31 Frederic St.
Entry Stair Details
□ = 2"

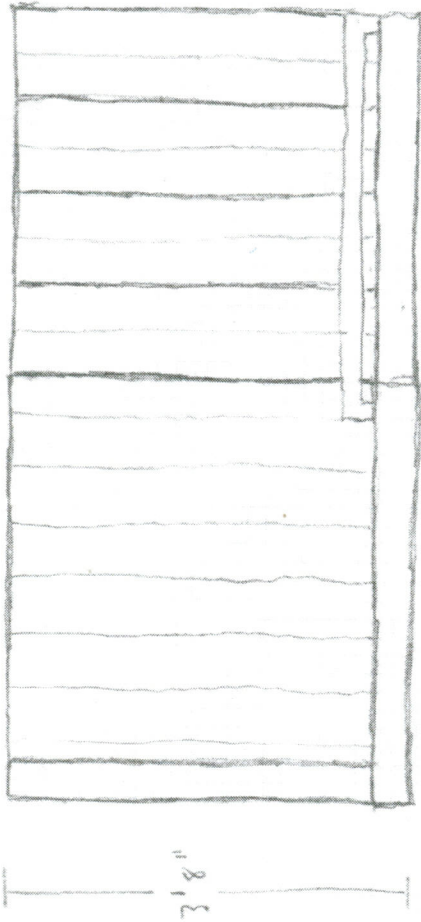
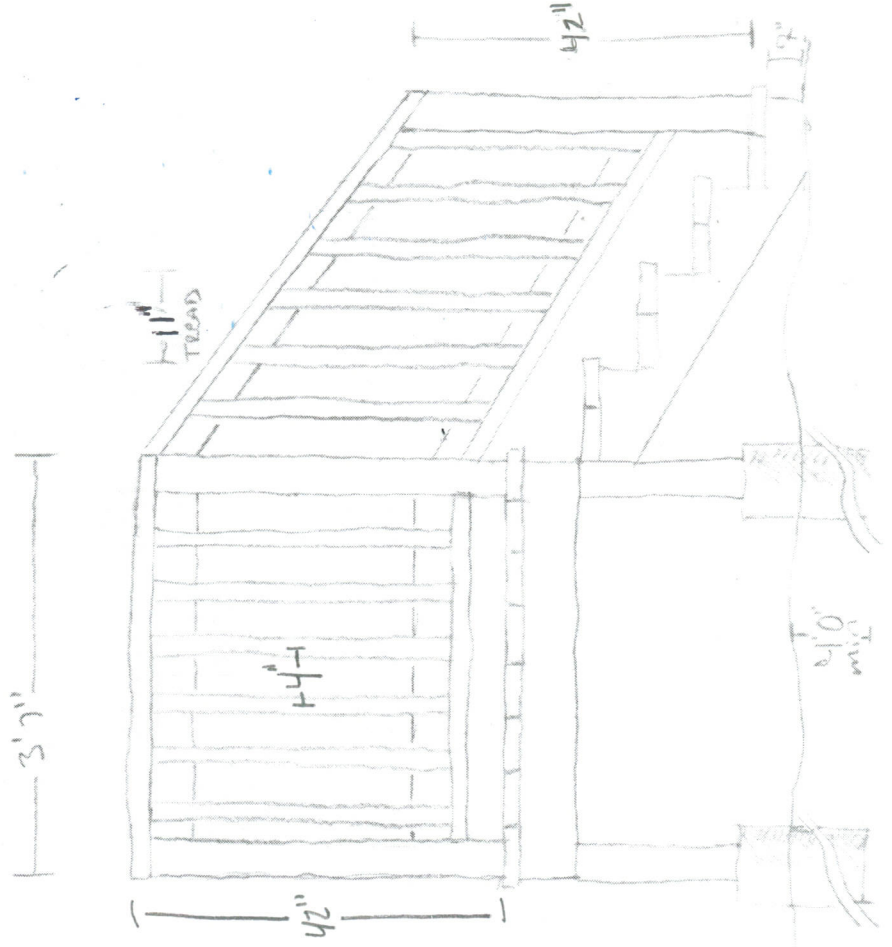
Per Section 1013.2 Guards provide height and opening limitations per code.

Per Section 1009 of the IBC, the minimum tread depth shall be 11". Please revise to meet code.

Provide framing plan for deck including size and spacing of joists and attachment connection to the house.
